RE: The Botanic – Riverhead – Proposed Retirement Village and Associated Activities

Thank you for your letter dated 1 December 2021 requesting further information on the above-mentioned proposal. The following sets out our responses following the headings in your letter:

0. STAGING PLAN
1:1000

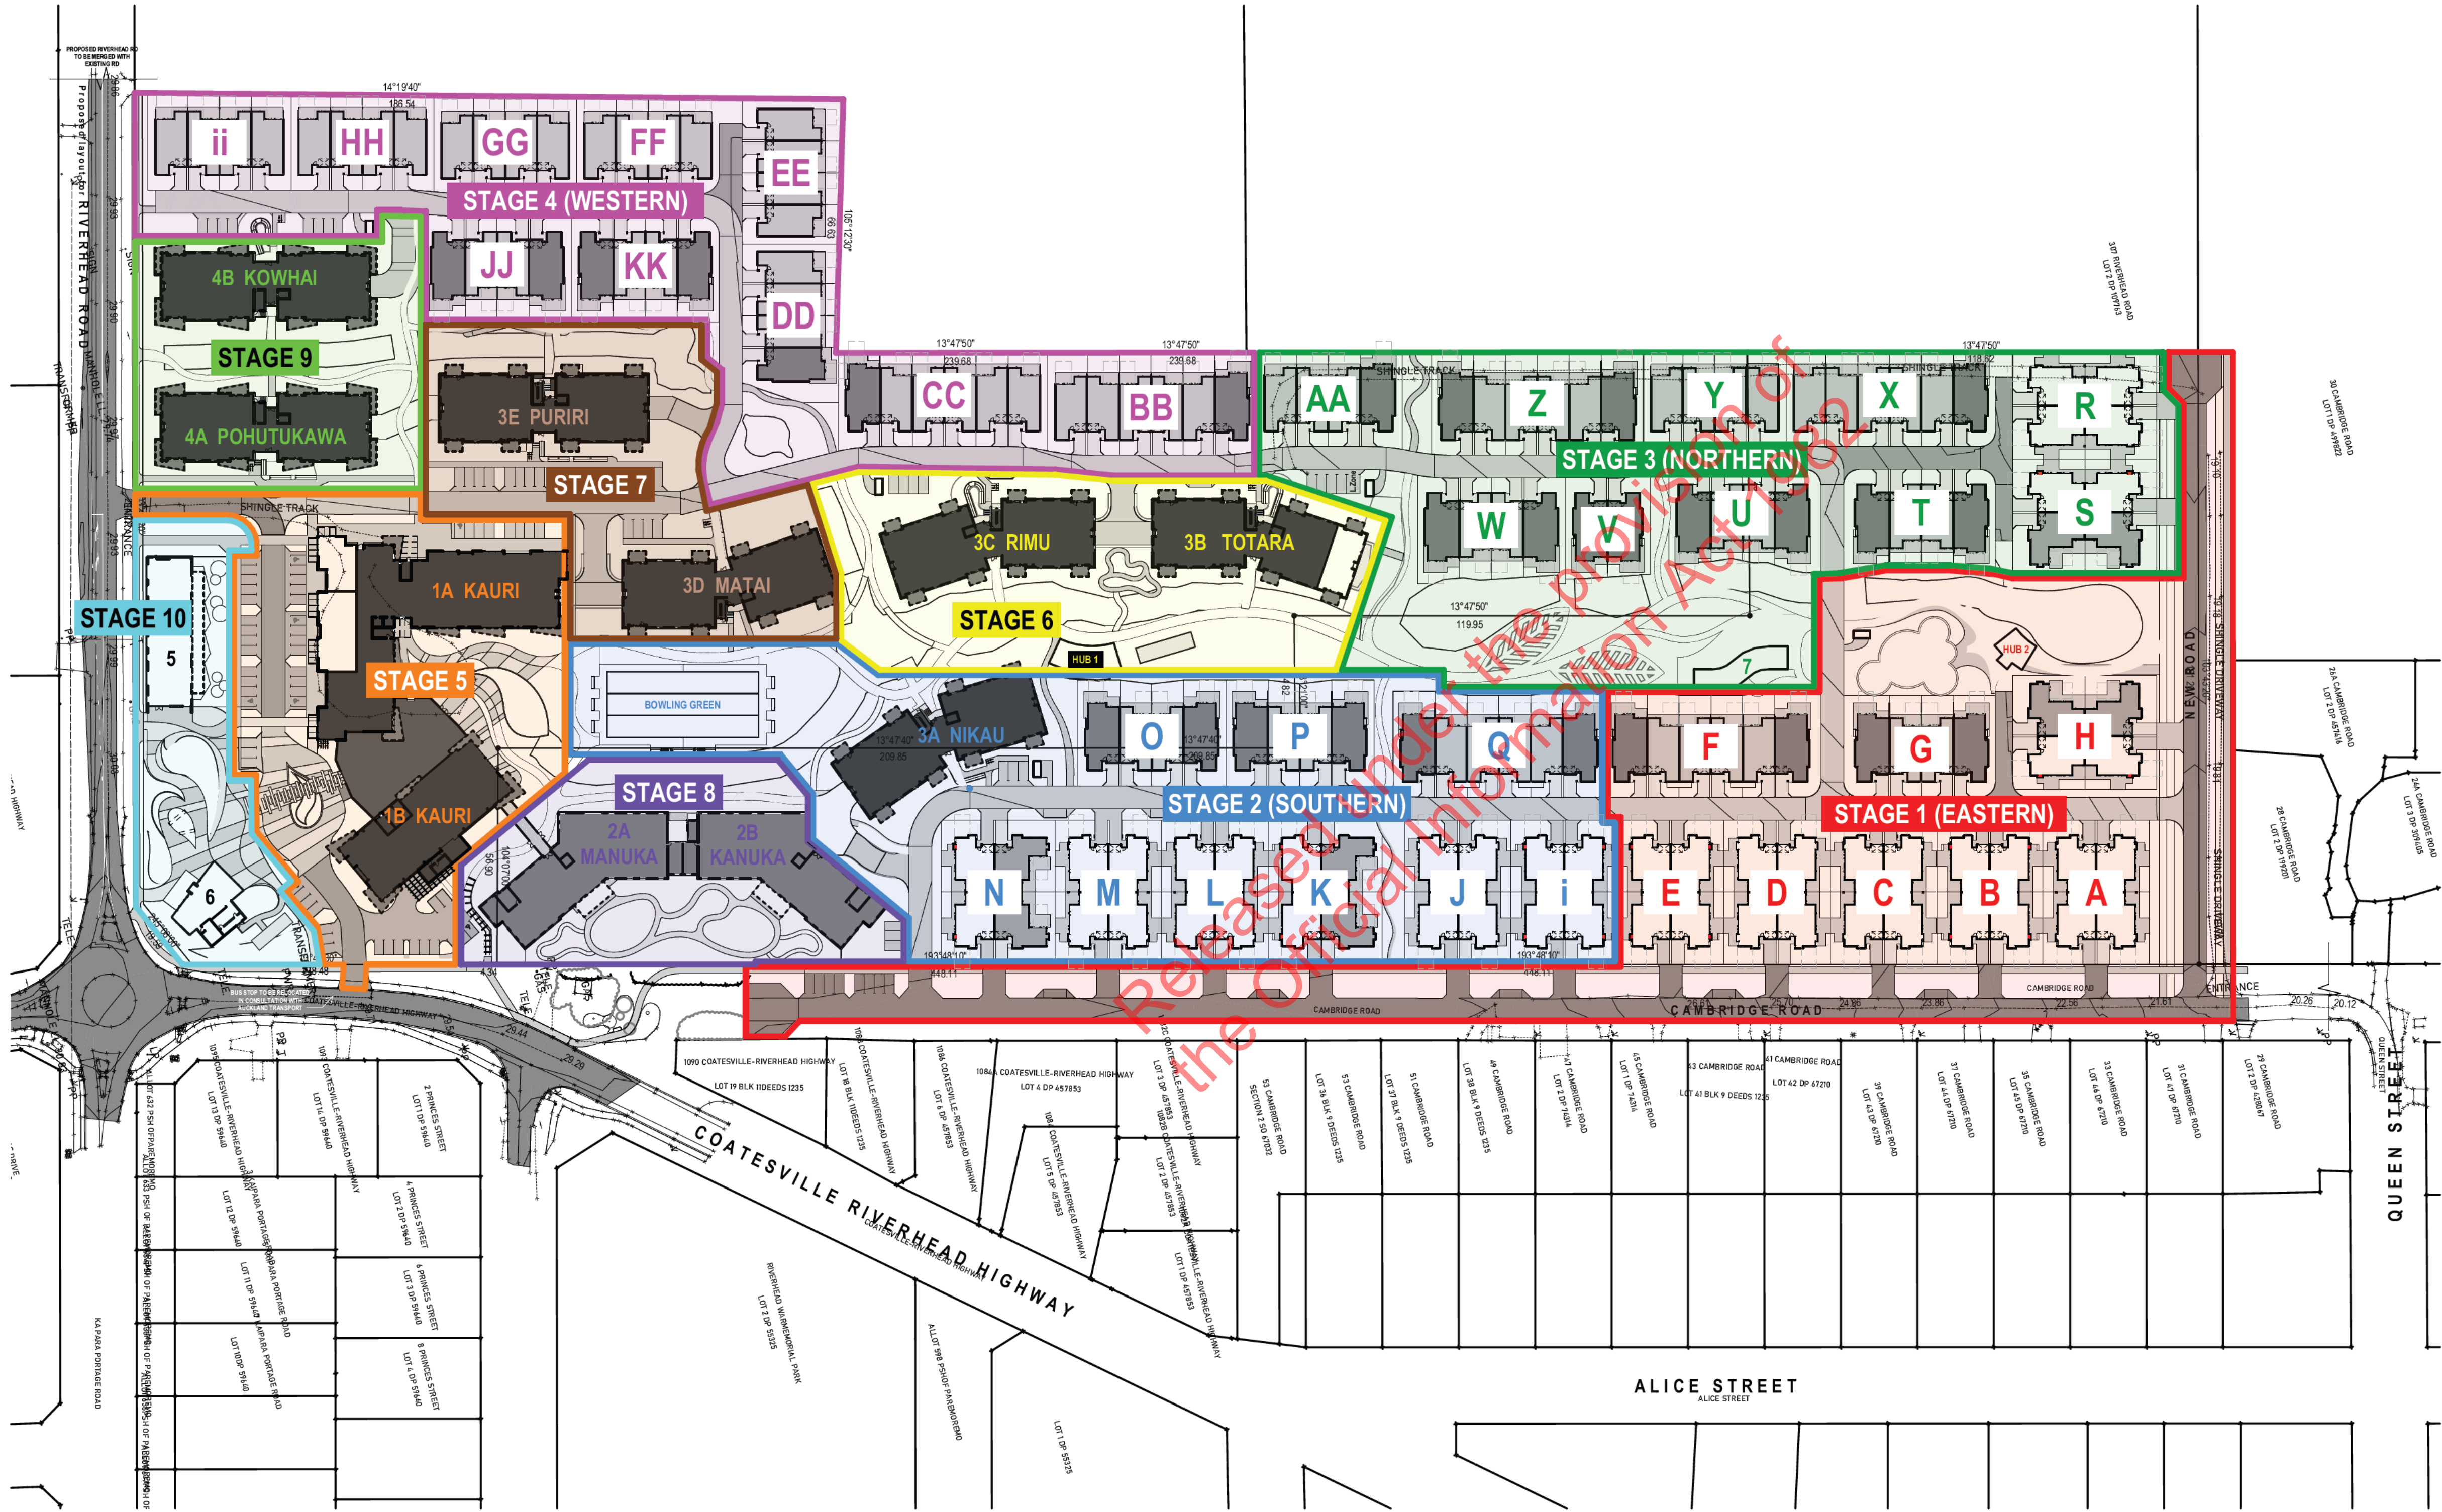
We also note that the development will be undertaken in stages, starting with the retirement villas at the northern end of the site and generally moving in a southerly direction, with the final stages of development being located adjacent to the Riverhead Road frontage of the site.

The first stages of development will have vehicle connections to Cambridge Road, a local road that extends along the eastern frontage of the site and connects to the wider network to the north, with construction access to the site also making use of the proposed left in/left out connection to Coatesville-Riverhead highway. Cambridge Road is part of the existing urban area of Riverhead.

On this basis, the urbanisation of Riverhead Road will not be necessary until the later stages of the development, with the trigger for this improvement work being when the right turn facility is required to accommodate turning movements into the site.
